REFERENCE:	Nova Bus Manuals
SECTION:	02: Doors and Mechanism
RS N°:	MQR 7621-1165
EFFECTIVE IN PROD.:	N/A

APPLICATION DEADLINE: 2019MA14  
CLAIM REFERENCE NUMBER: WB-4153

SUBJECT:	Front door - Upper brush cover seal
JUSTIFICATION:	Automatic Passenger Counter may report erroneous data due to dust or water intrusion on optical front door sensor lens.

Figure 3 - Alignment of Rubber Seal

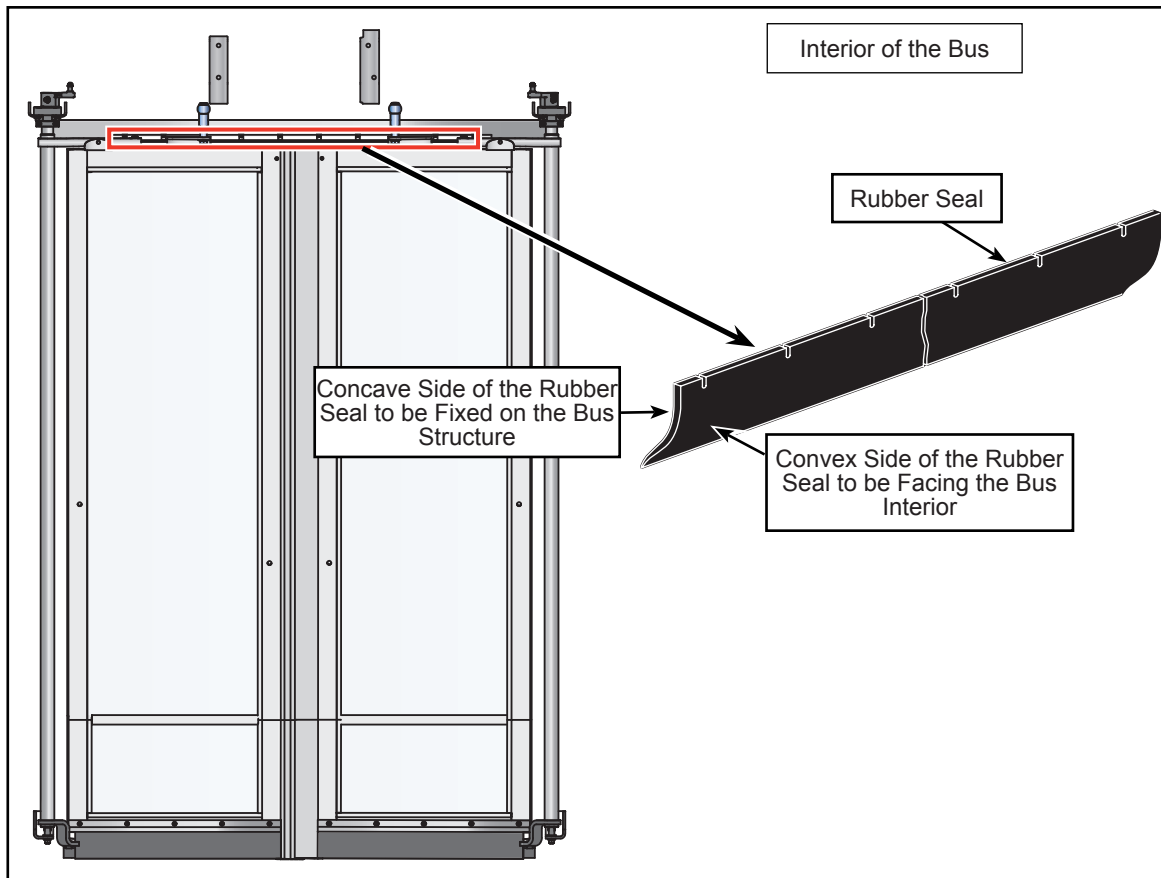
The rubber seal must be installed correctly. Its positioning is determined by the curve in the rubber seal. The rubber seal must curve toward the door.

- 1.6. Align the holes of rubber seal (N91377) with the pre-existing holes on the door structure (see Figure 3).

Figure 4 - Installation of Rubber Seal

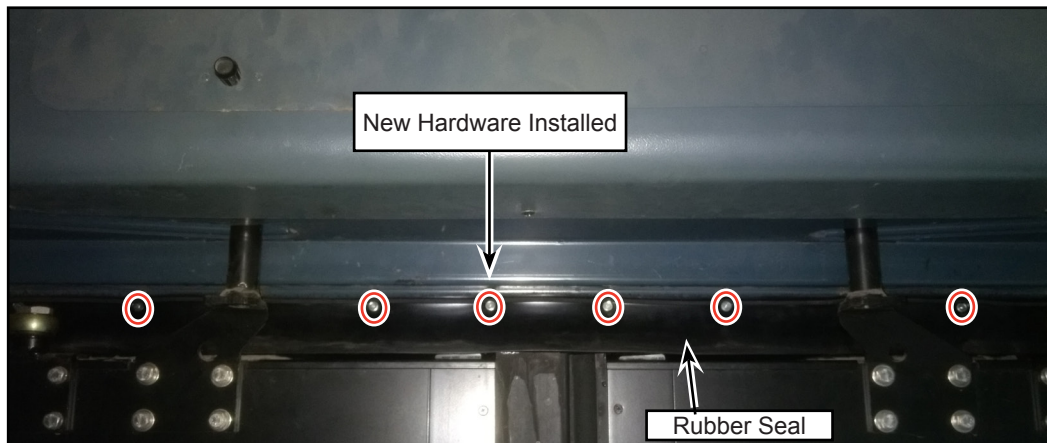
- 1.7. Secure the rubber seal and upper door brush with the new screws (N20265) and washers (N8906932) (see Figure 4).
